**REVISED RESPONSE TO REQUEST FOR ADDITIONAL INFORMATION****APR1400 Design Certification****Korea Electric Power Corporation / Korea Hydro & Nuclear Power Co., LTD****Docket No. 52-046**

**RAI No.:** 49-7825

**SRP Section:** 06.02.01.05 – Minimum Containment Pressure Analysis for ECCS Performance Capability Studies

**Question No. 06.02.01.05-1**

Figure 06.02.01.05-1-1. Pressure Comparison between Current and Revised Containment input

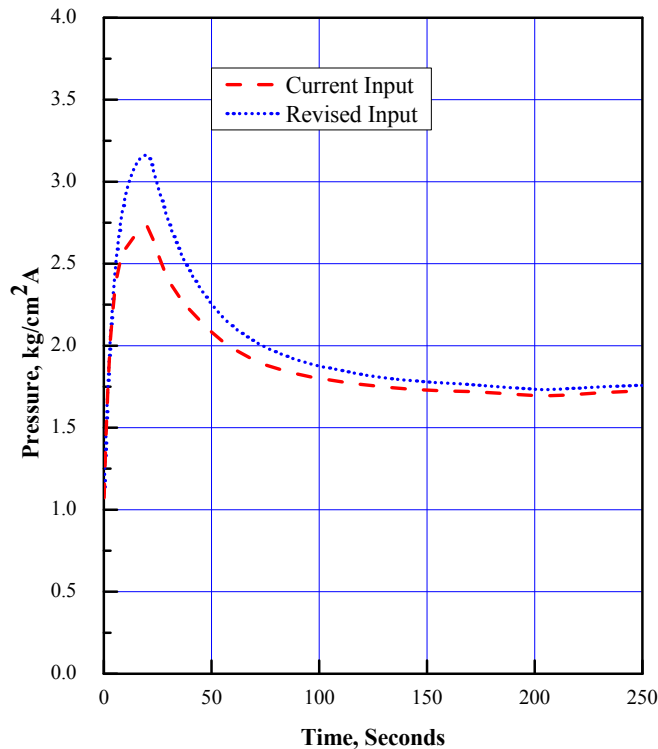
In Design Control Document (DCD) Tier 2, Section 6.2.1.5.4, the containment free volume used for the minimum pressure calculation is specified, and includes a “consideration of uncertainty.” In a response to the RAI, provide additional detail on the value of this uncertainty, including the magnitude and reasoning used to determine the value, and provide what degree of margin there is from the calculated value versus the expected asbuilt free volume. Update DCD Tier 2, Section 6.2.1.5.4 with the margin used in the minimum pressure calculation. The staff needs this information to assess the degree of conservatism in the analysis.

Figure 06.02.01.05-1-1 shows a comparison of the containment pressure using the current containment input against the revised input. The passive heat sink data of current containment input are constructed by merging 10 heat structures of conservative surface area and wall thickness. The 19 heat structures are modeled with the direct reflection of the revised containment input design data. (See markup in Attachment 1)
